**BCC DS**  
**RECEIVED**  
08-MAY-2026  
**APPLICATION REF**  
A007020190

DA Set - 21.02.2024.

DA Set - 15.02.2026.

Rev\_16

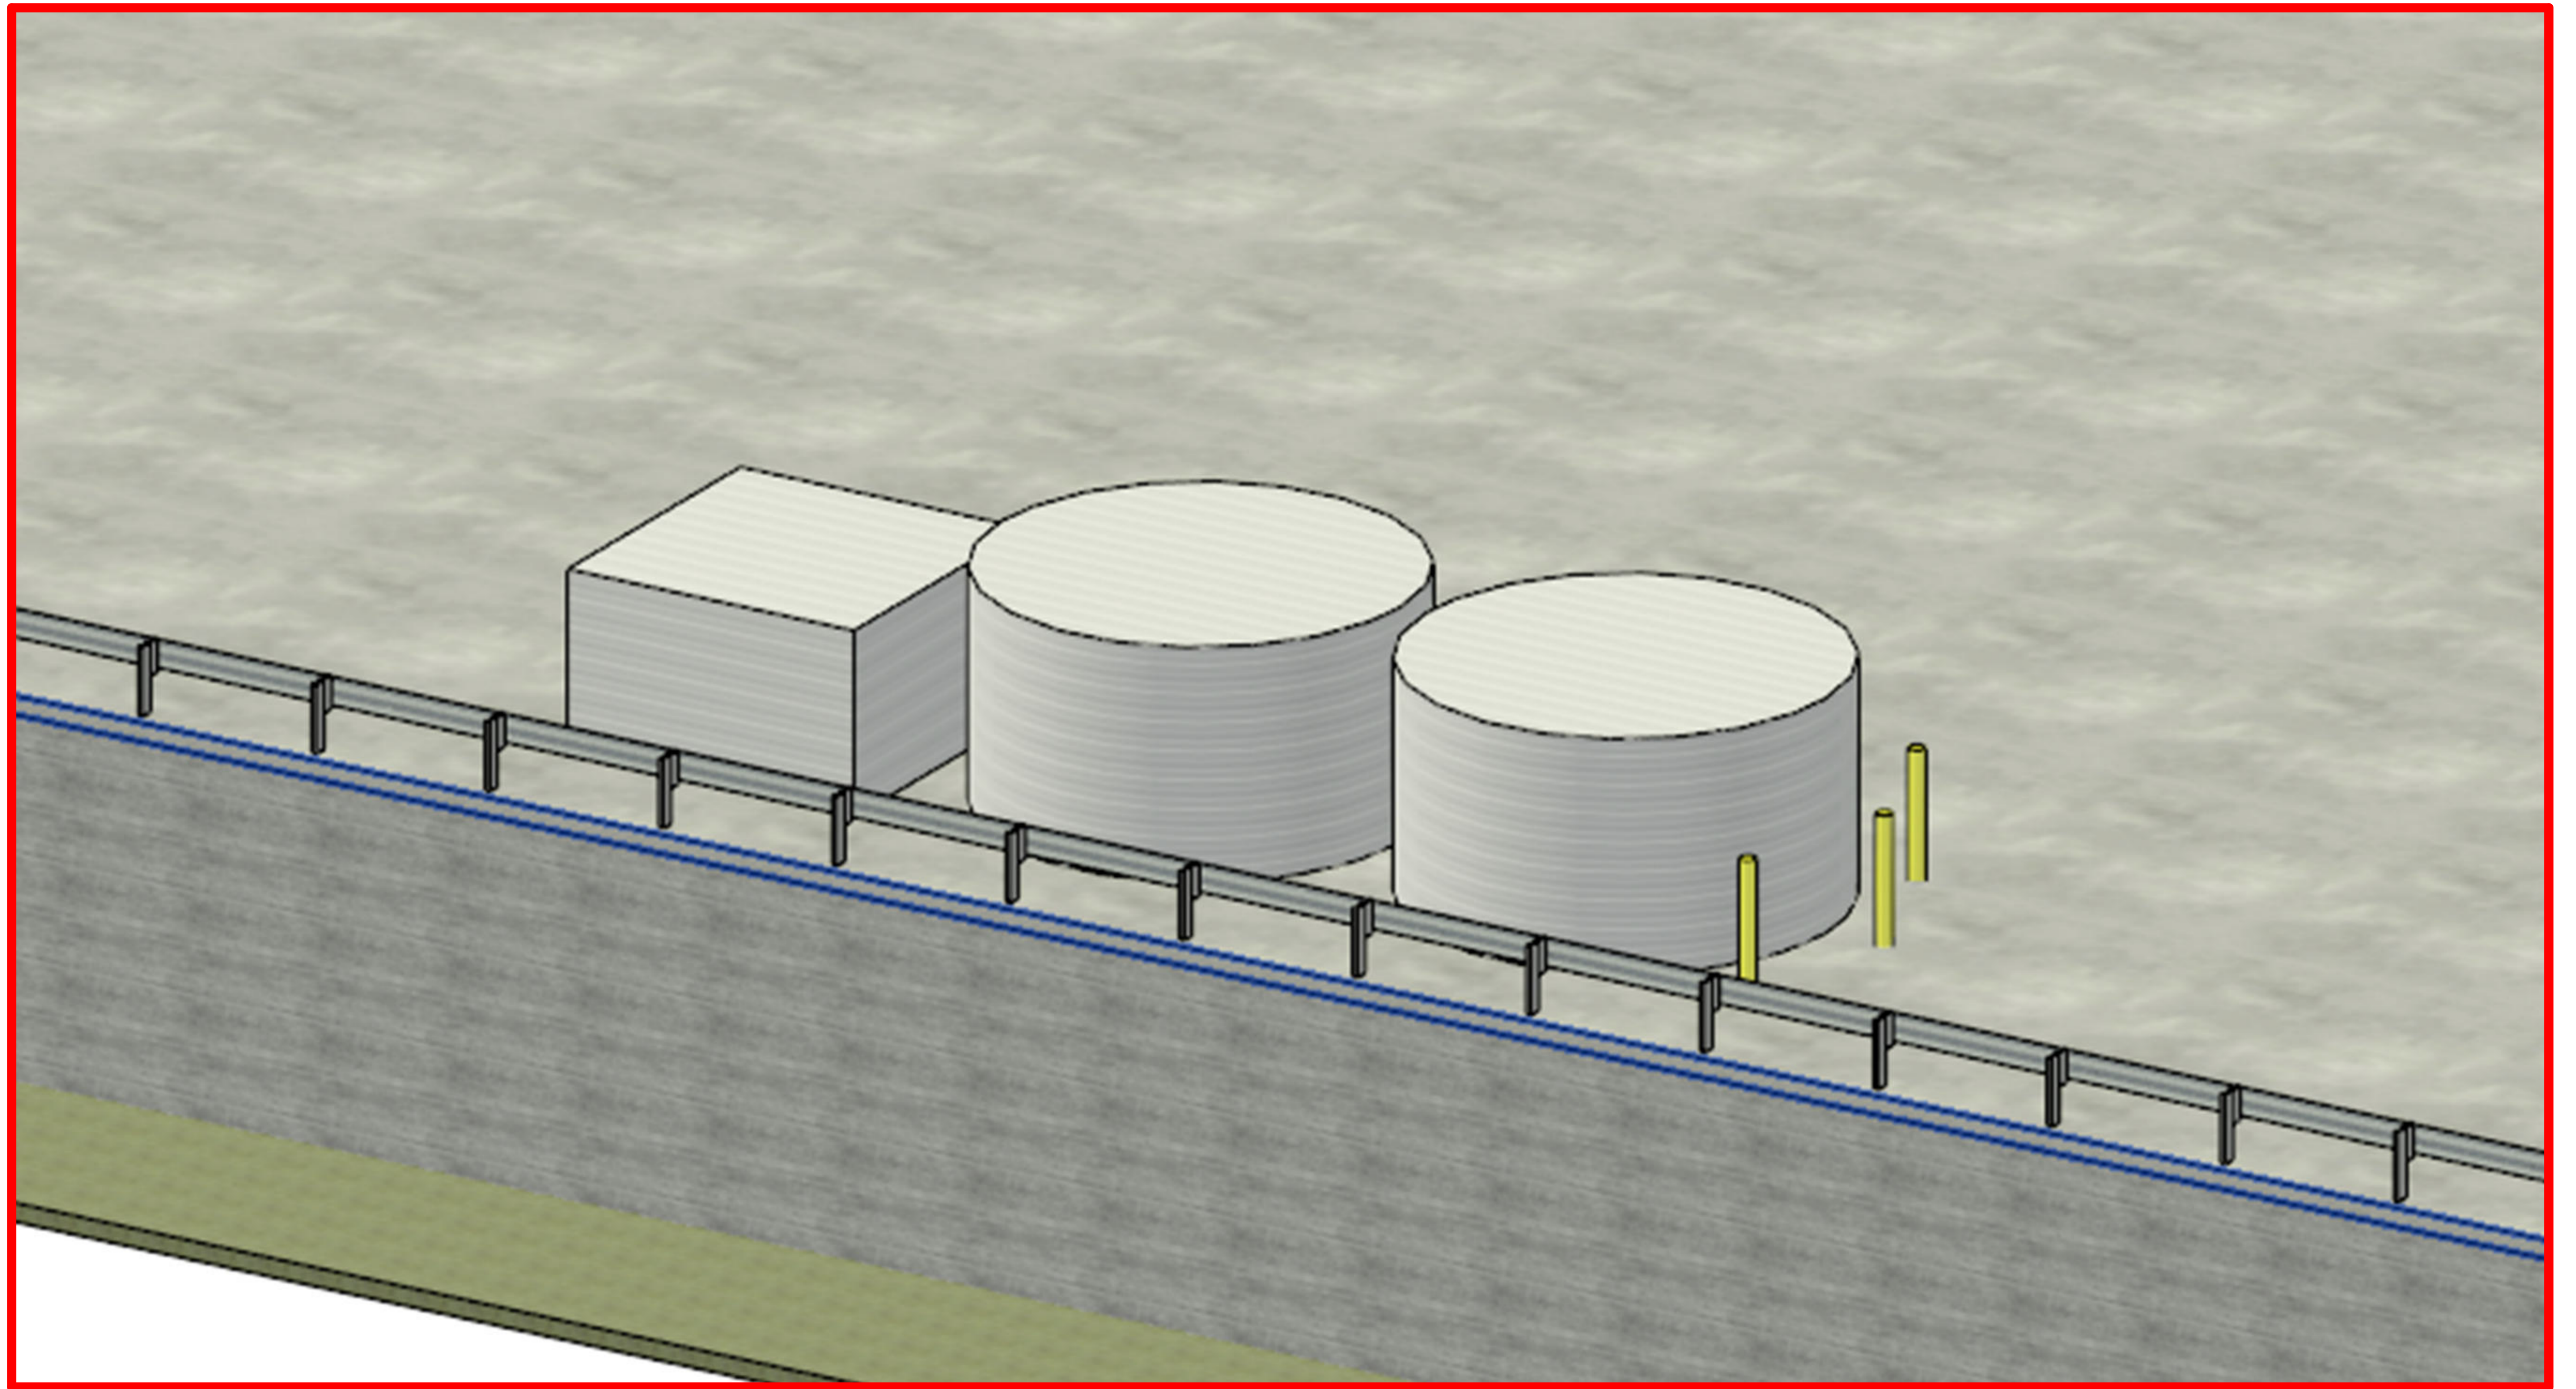
16. A standalone driver's toilet has been added.

17. Fire protection sprinkler and holding tanks have been added.

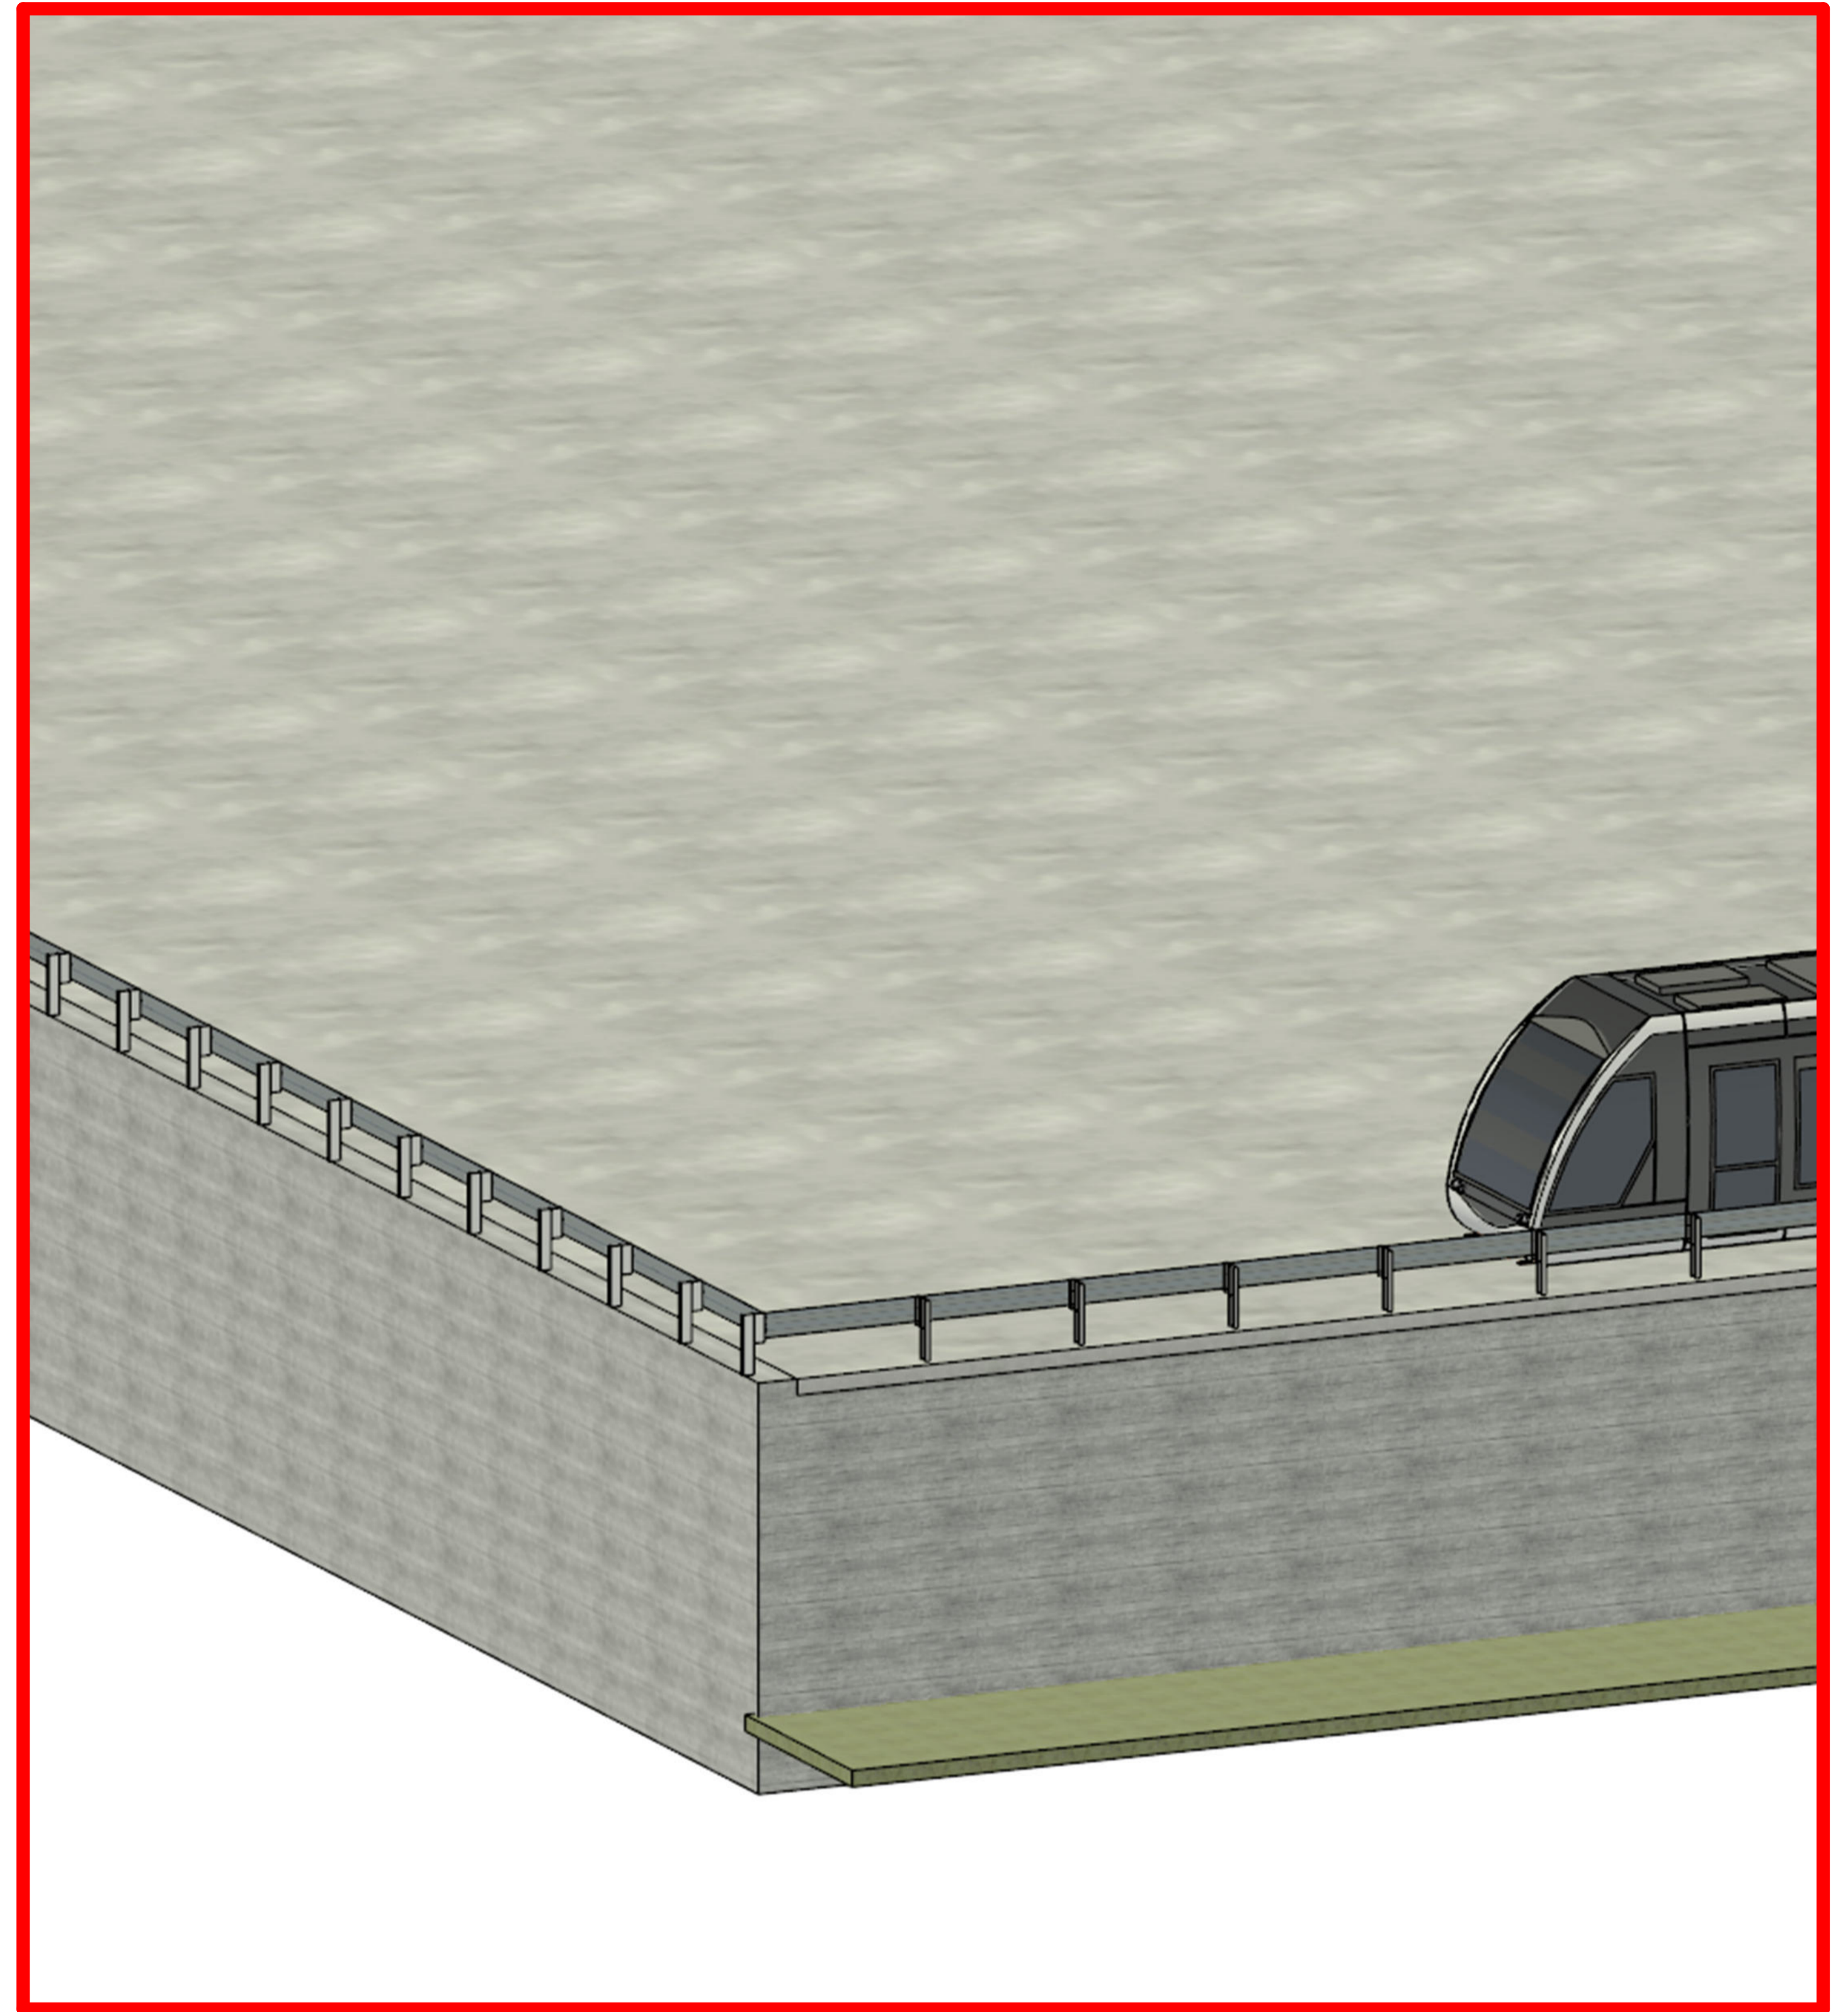
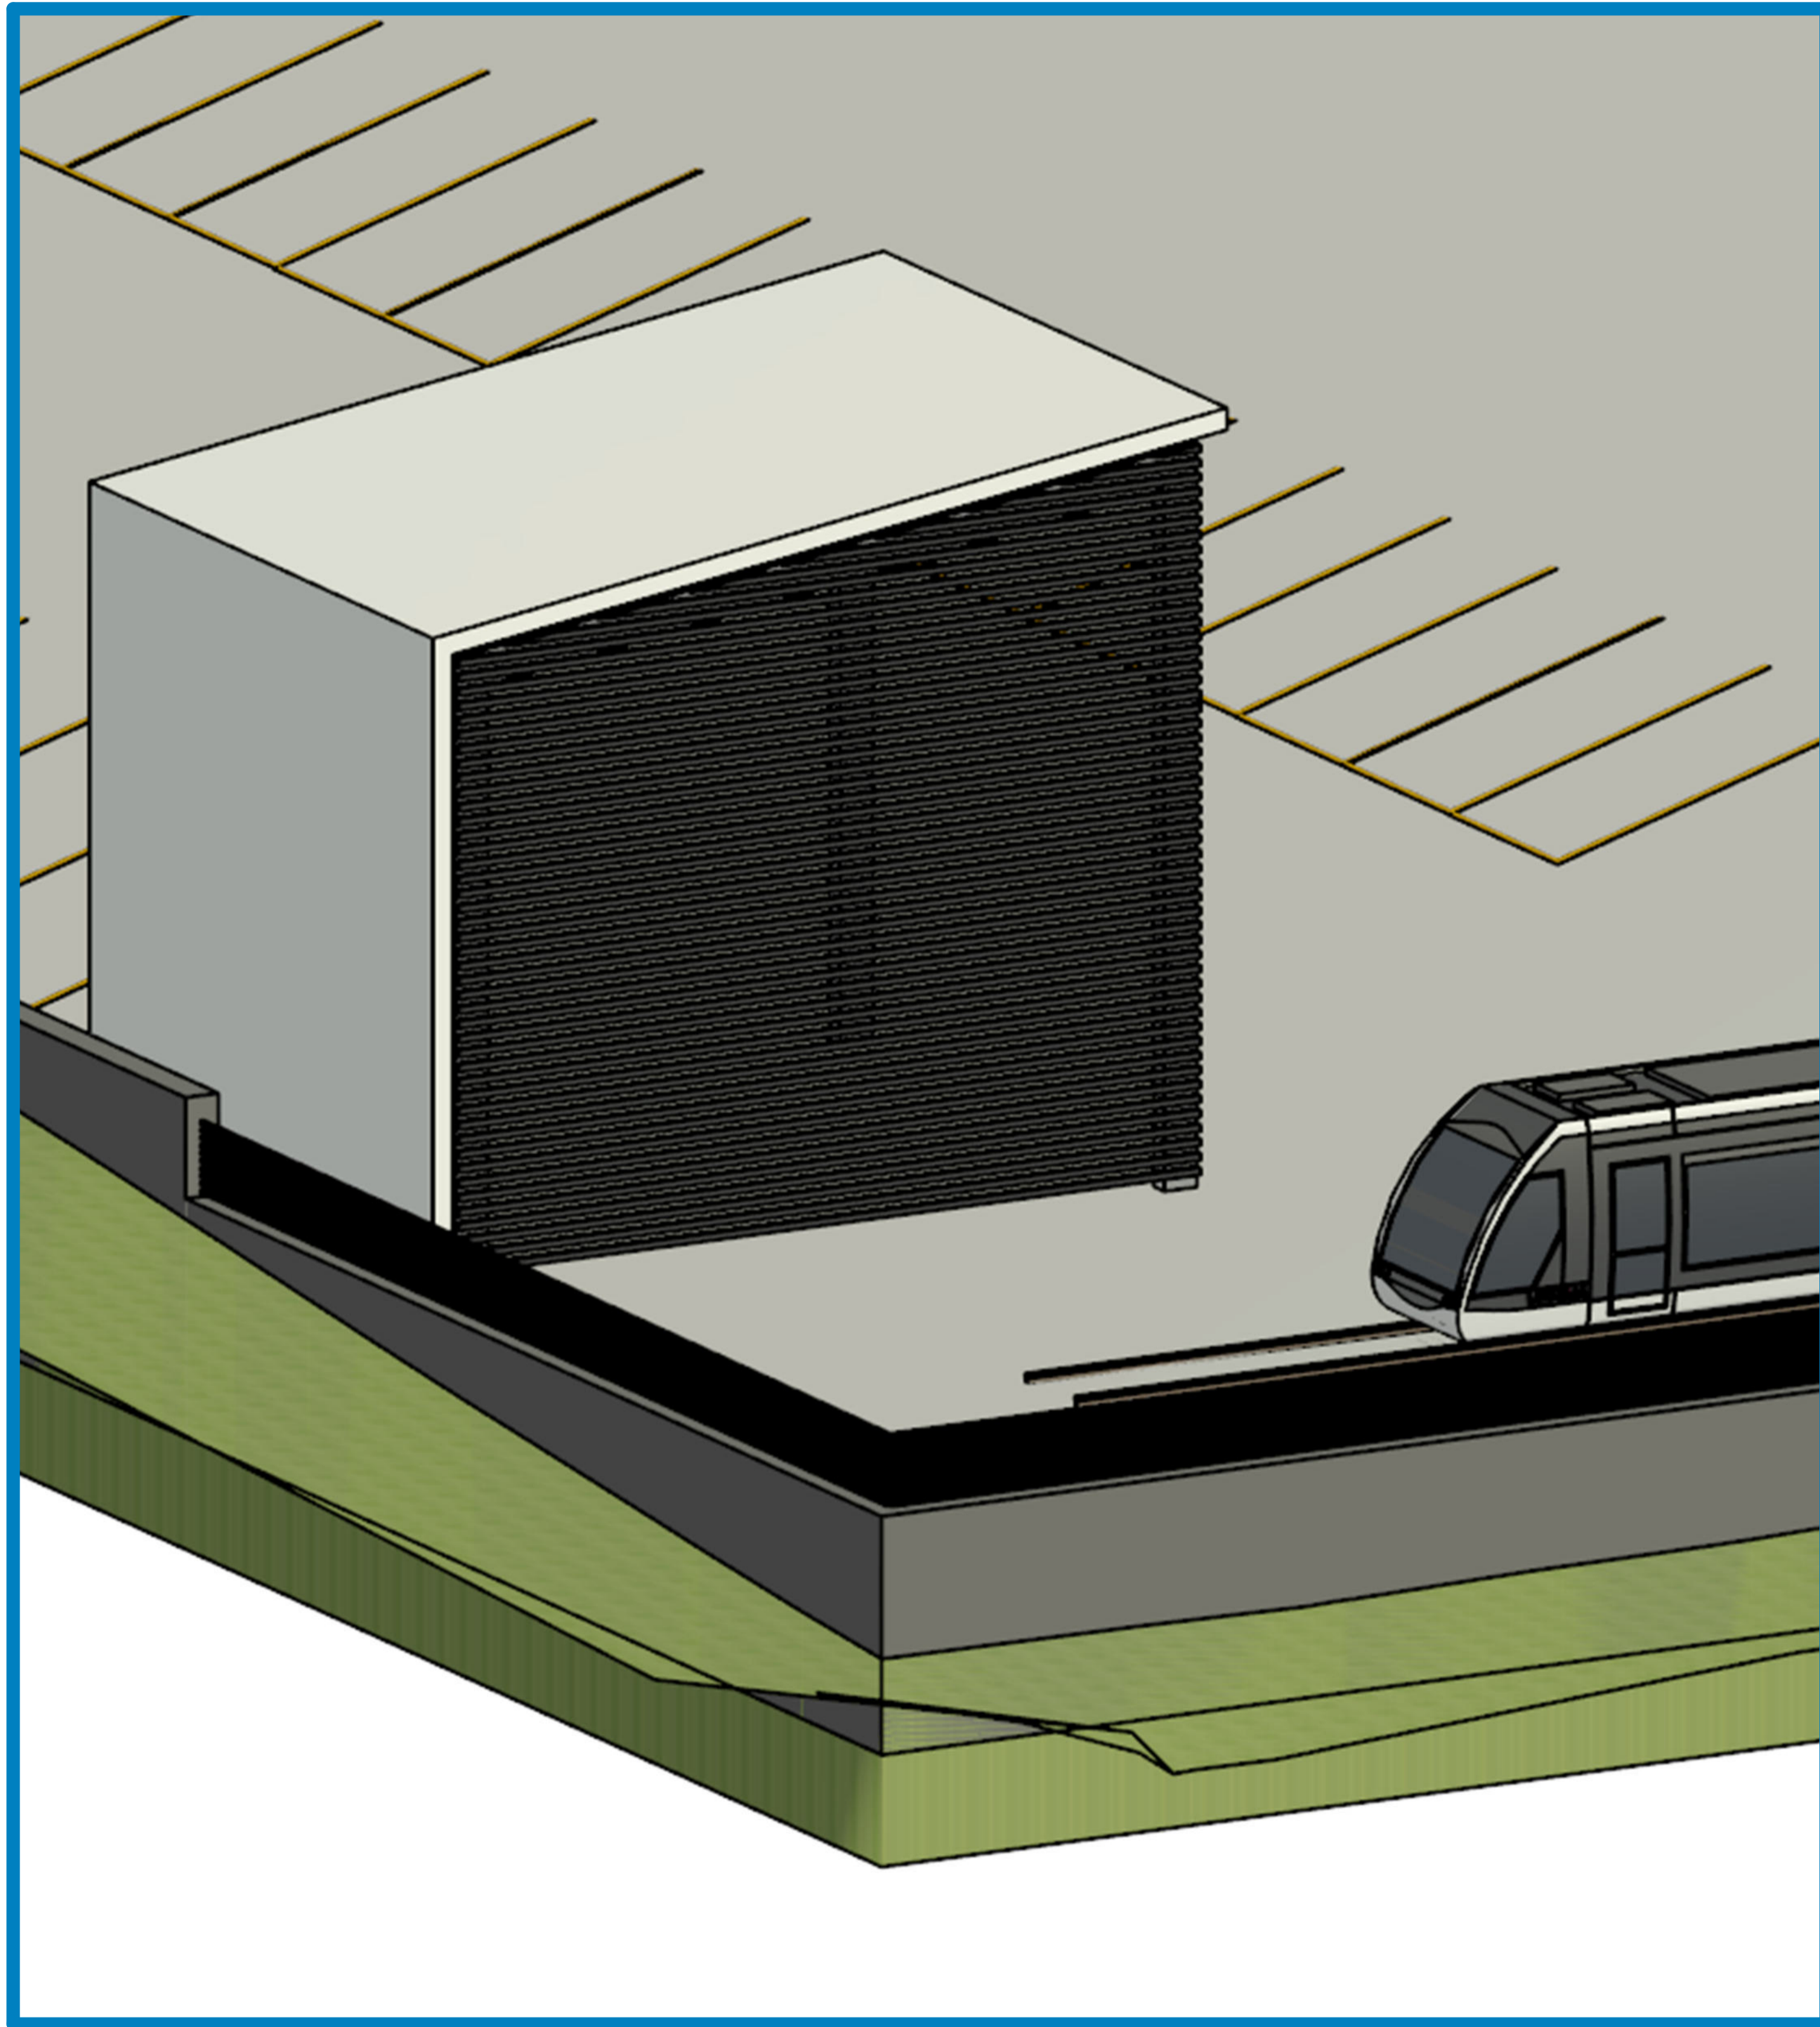
18. An Armco safety barrier has been installed.
